Change Order

Williamson County
Animal Shelter Expansion
1855 SE Inner Loop
Georgetown, TX 78626

Change Order Number: 006

Change Order No. 6 includes the below listed Vaughn Change Proposals # 27-#31. For Vaughn Project No. 2491-01.

M.2-2.10

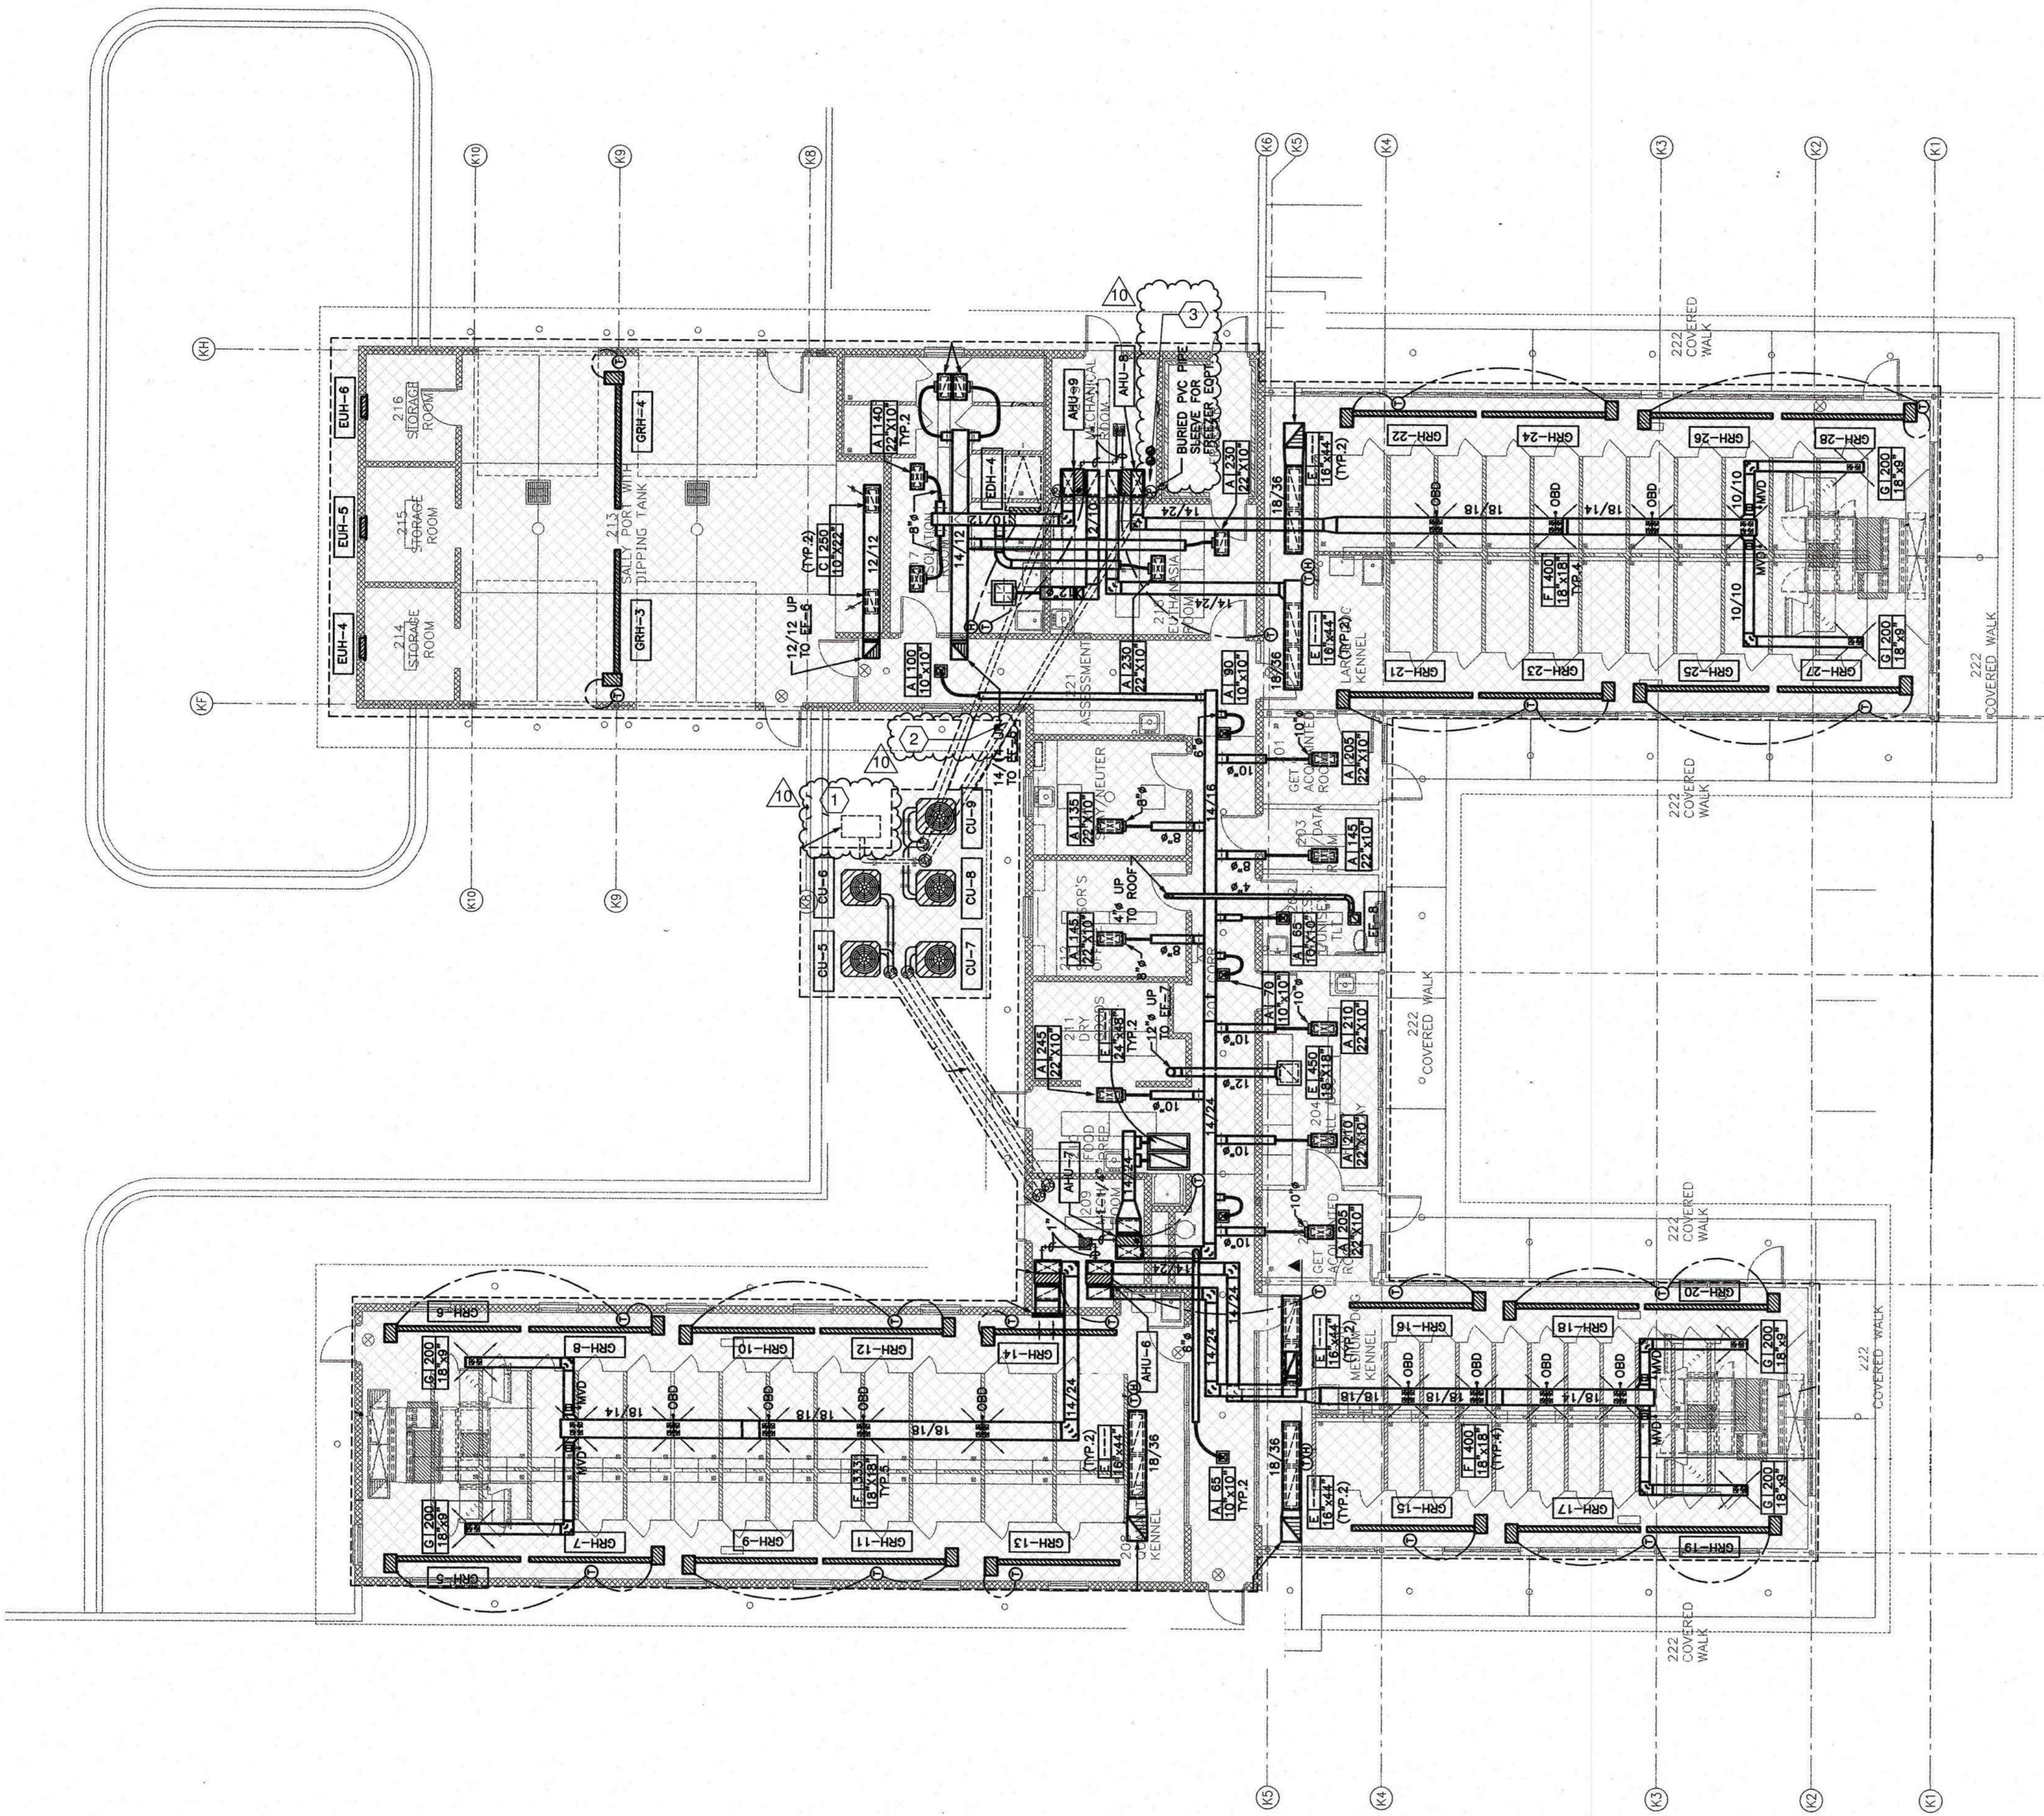
Re: Existing Freezer Condensing Unit Relocation

The existing freezer condensing unit at the Kennel Building will need to be relocated due to the demolition of the existing pad. Please see the attached showing the proposed new location and let us know if this is acceptable and what requirements will be needed for the relocation.

- 1 RELOCATE EXISTING FREEZER CONDENSING UNIT TO LOCATION MARKED ON SHEET M.2-3.01. DEMO PVC PIPING TO LOCATION INDICATED BY KEYED NOTE 2 AND CAP THE PVC PIPING THERE. ABANDON PVC PIPING UNDER THE BUILDING SLAB. DEMO EXISTING REFRIGERANT PIPING TO LOCATION INDICATED BY KEYED NOTE 3. REUSE EXISTING CONDENSING UNIT PAD. IF PAD CANNOT BE REUSED PROVIDE AN IDENTICAL PAD FOR THE NEW LOCATION. PAD SHOULD
- 2 CAP EXISTING PVC PIPING HERE. ABANDON PVC PIPING UNDER THE BUILDING SLAB.
- 3 REFRIGERANT PIPING THRU FLOOR.

E.2-3.21

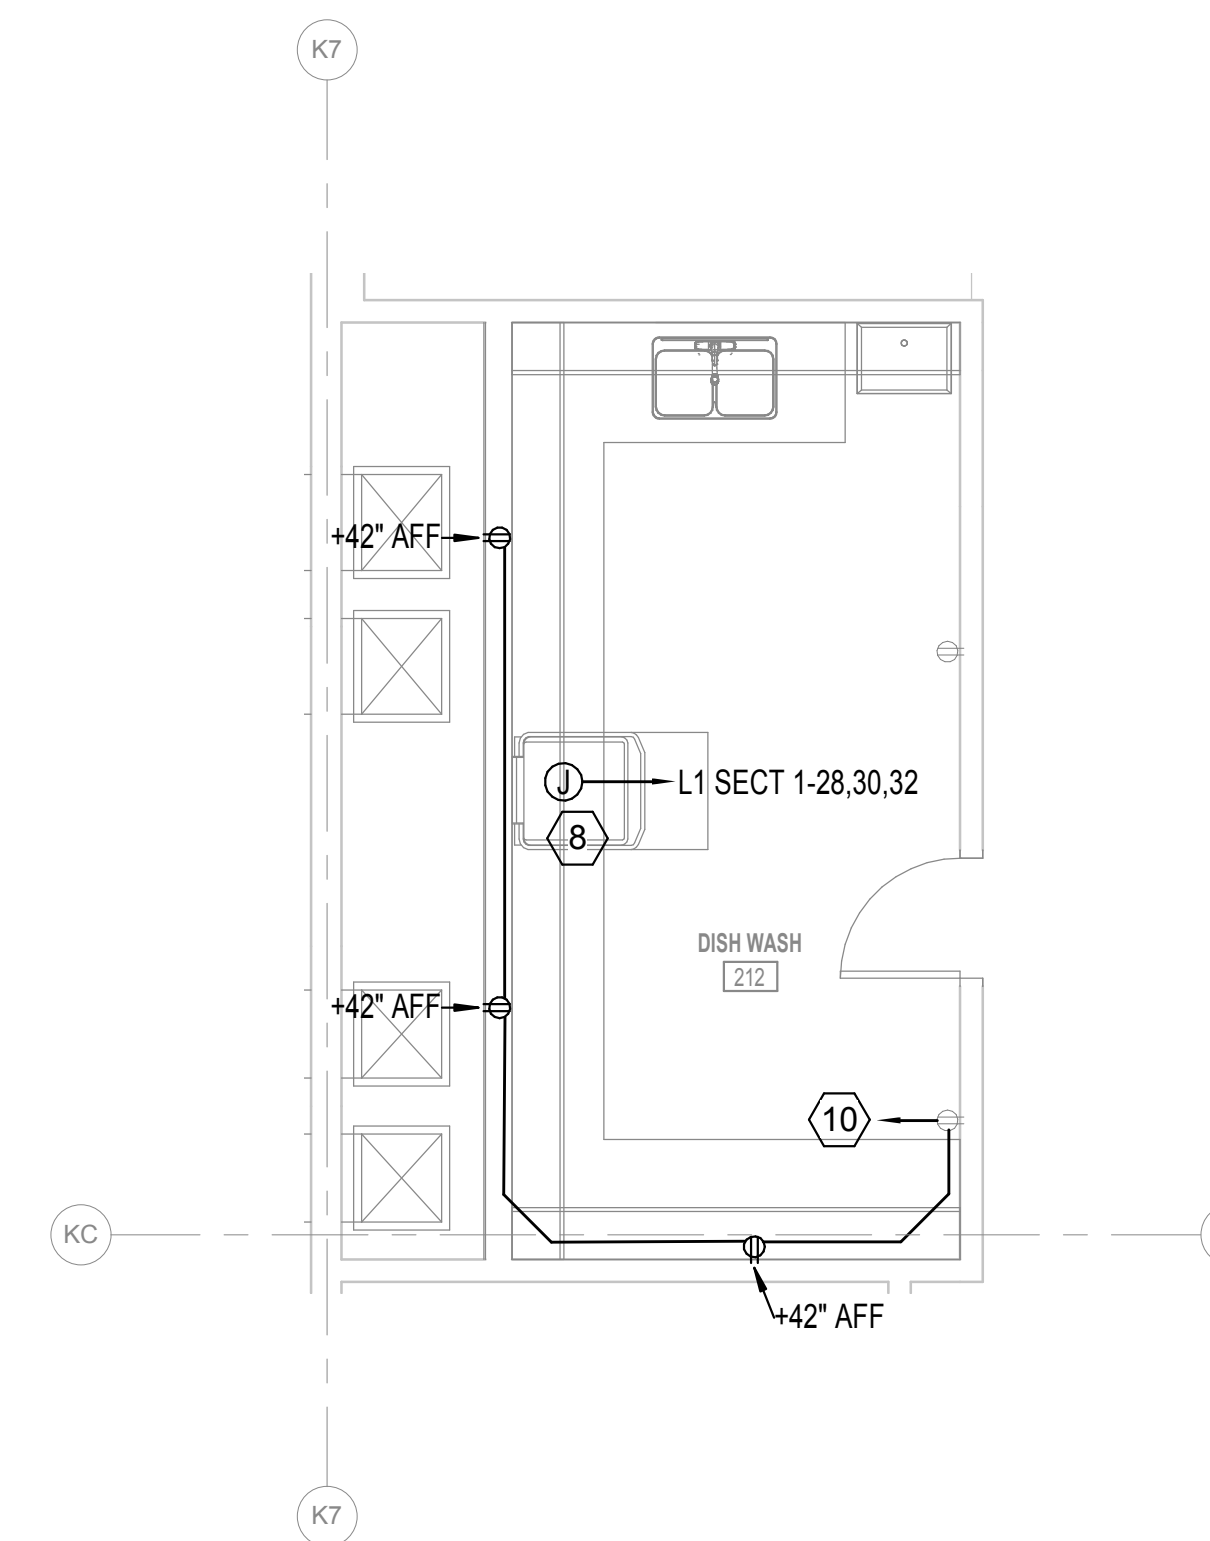
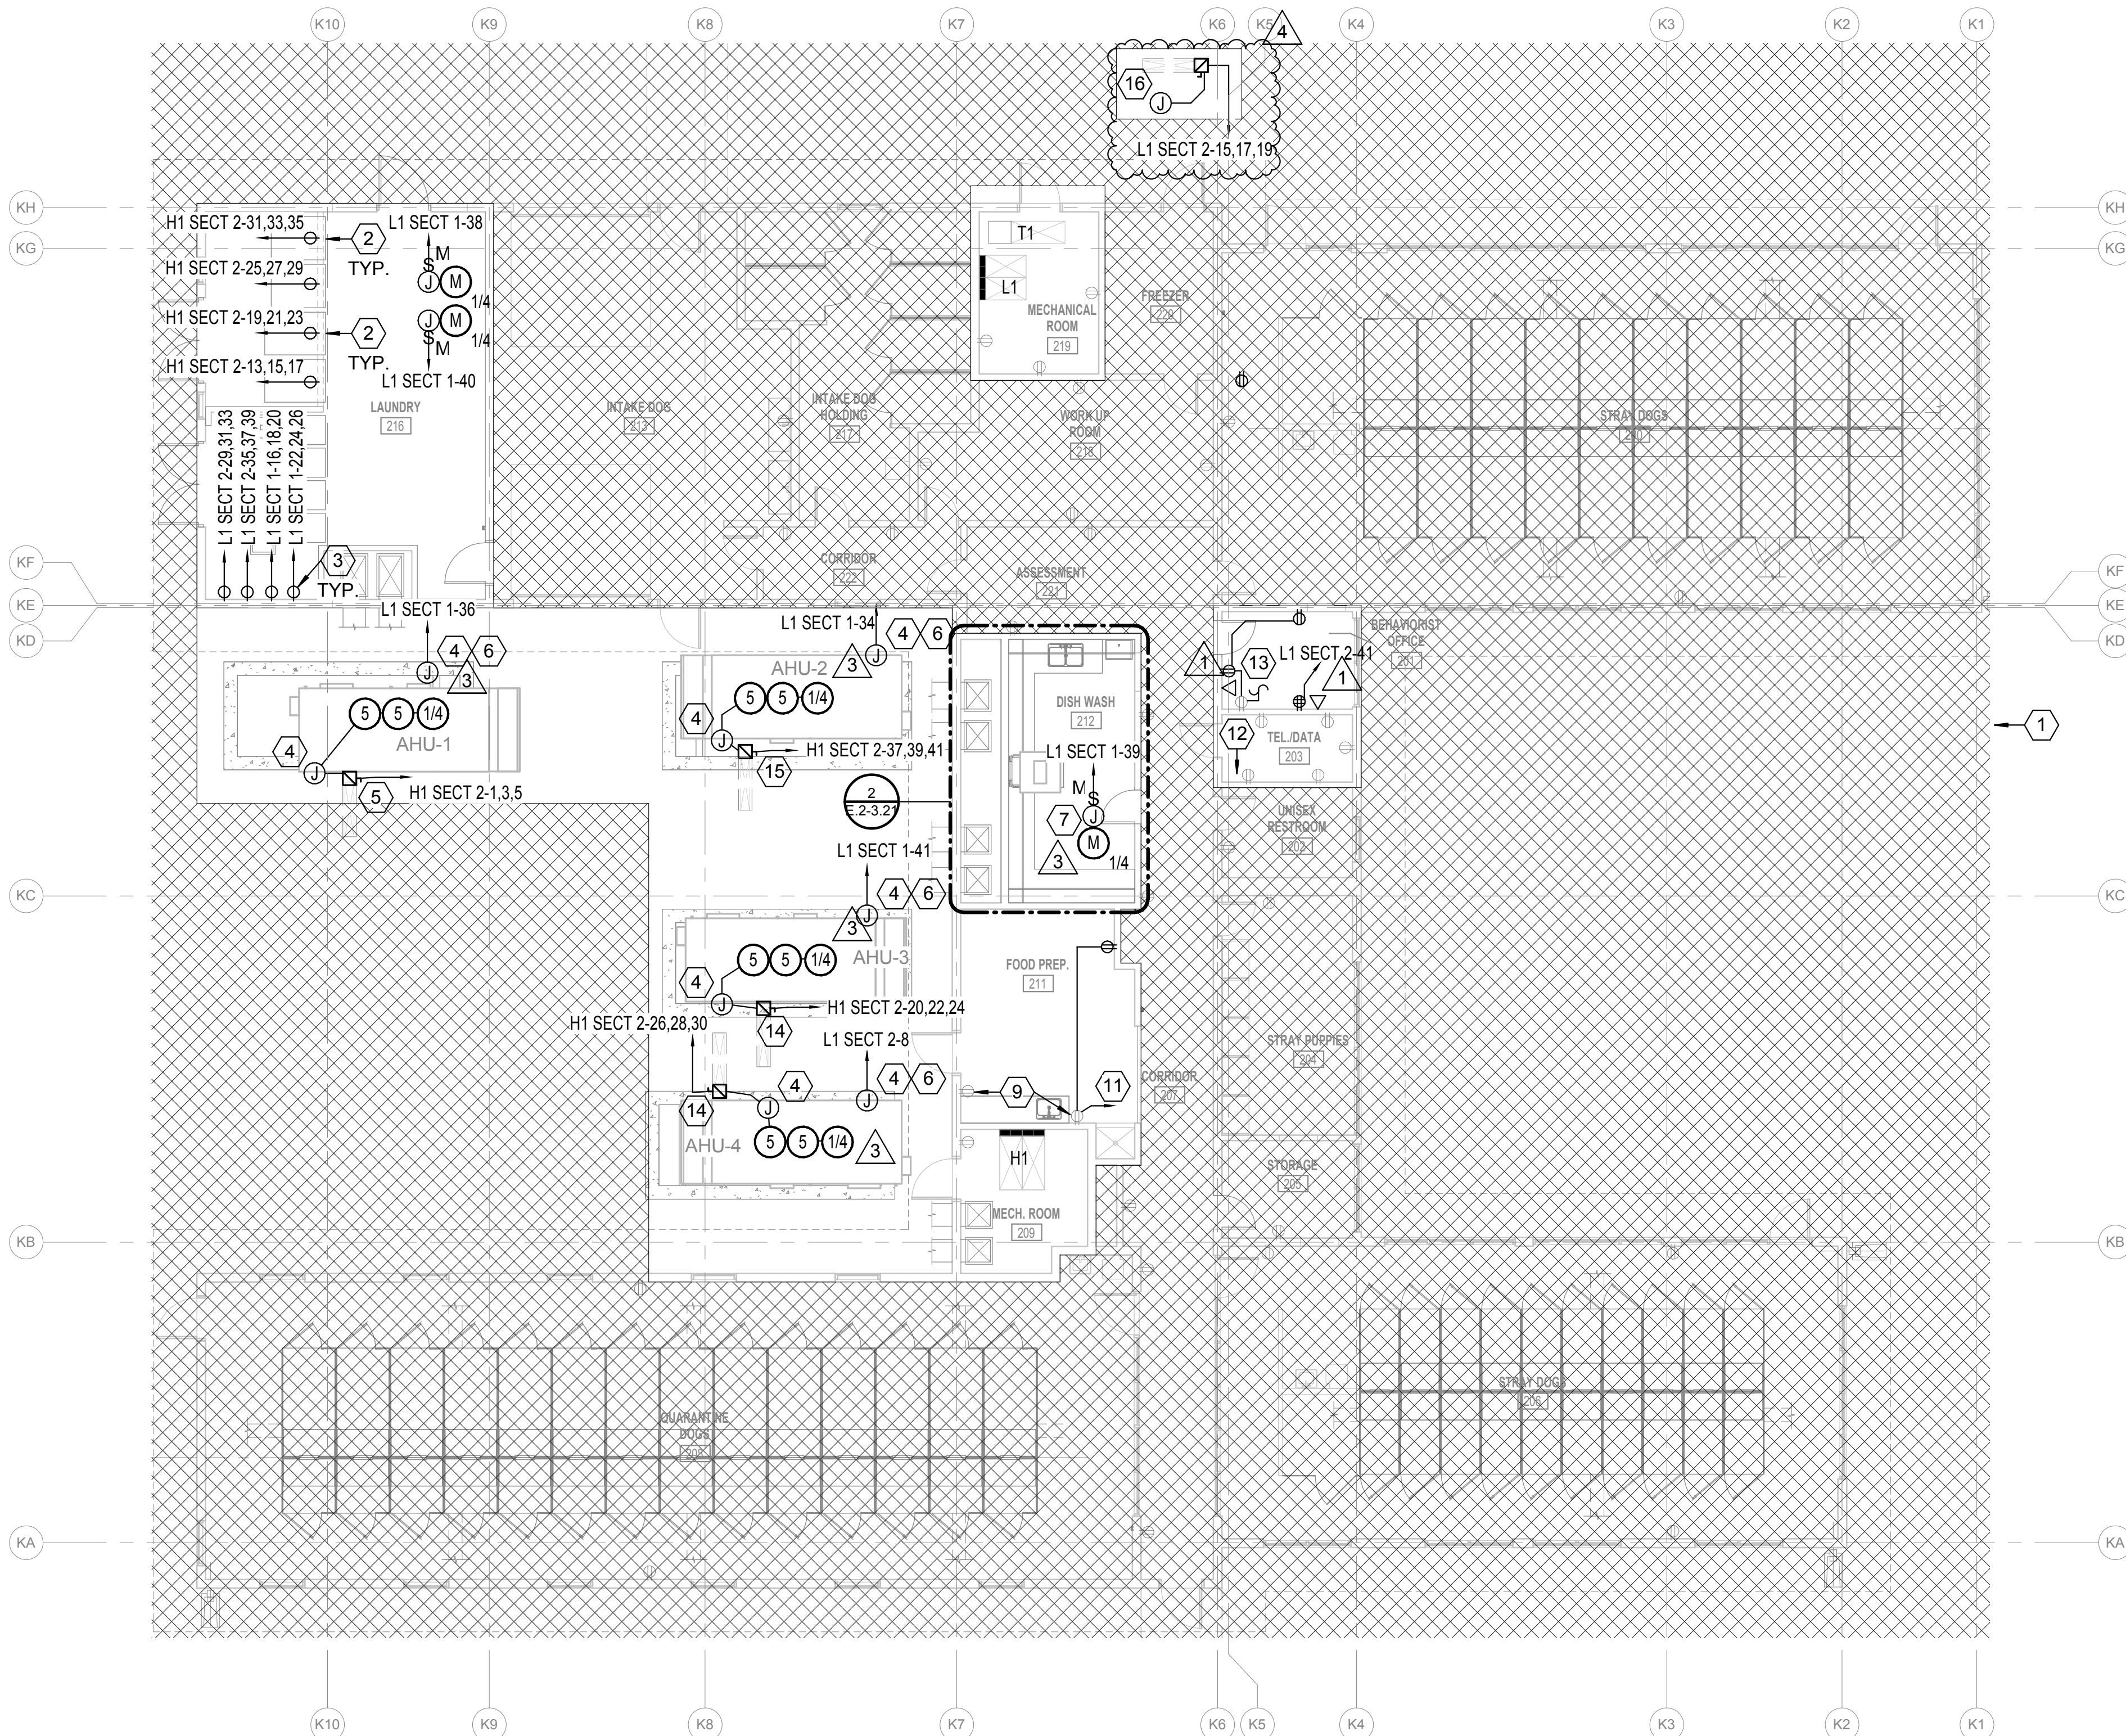
- 5 PROVIDE NEMA 3R, 60A/3P/600V RATED DISCONNECT FUSED AT 50A. UNISTRUT MOUNT DISCONNECT TO EQUIPMENT PAD. COORDINATE LOCATION WITH DIV 23.
- 6 PROVIDE POWER TO MECHANICAL EQUIPMENT AUXILIARIES (LIGHTING, RECEPTACLES, ETC.)
- 7 PROVIDE POWER TO EXHAUST FAN ON ROOF. COORDINATE EXACT LOCATION WITH DIV 23.
- 8 PROVIDE POWER TO COMMERCIAL DISH WASHER.
- 9 REPLACE RECEPTACLE WITH GFCI-PROTECTED RECEPTACLE.
- 10 CONNECT NEW RECEPTACLES TO EXISTING CIRCUIT SERVING DISHWASH 212.

- 11 CONNECT NEW RECEPTACLES TO EXISTING CIRCUIT SERVING FOOD PREP 211.
- 12 EXTEND EXISTING CONDUIT FROM KENNEL TELECOM ROOM TO NEW ADOPTIONS TELECOM ROOM.
- 13 CONNECT NEW RECEPTACLES TO EXISTING CIRCUIT SERVING ROOM 201.
- 14 PROVIDE NEMA 3R, 60A/3P/600V RATED DISCONNECT FUSED AT 40A. UNISTRUT MOUNT DISCONNECT TO EQUIPMENT PAD. COORDINATE LOCATION WITH DIV 23.
- 15 PROVIDE NEMA 3R, 100A/3P/600V RATED DISCONNECT FUSED AT 70A. UNISTRUT MOUNT DISCONNECT TO EQUIPMENT PAD. COORDINATE LOCATION WITH DIV 23.
- 16 RELOCATED FREEZER CU. RUN CONDUIT ALONG WALL PARALLEL TO THE REFRIGERANT LINE. INSTALL RELOCATED DISCONNECT. REUSE EXISTING CIRCUIT BREAKER IN PANEL L1 SECT 2.
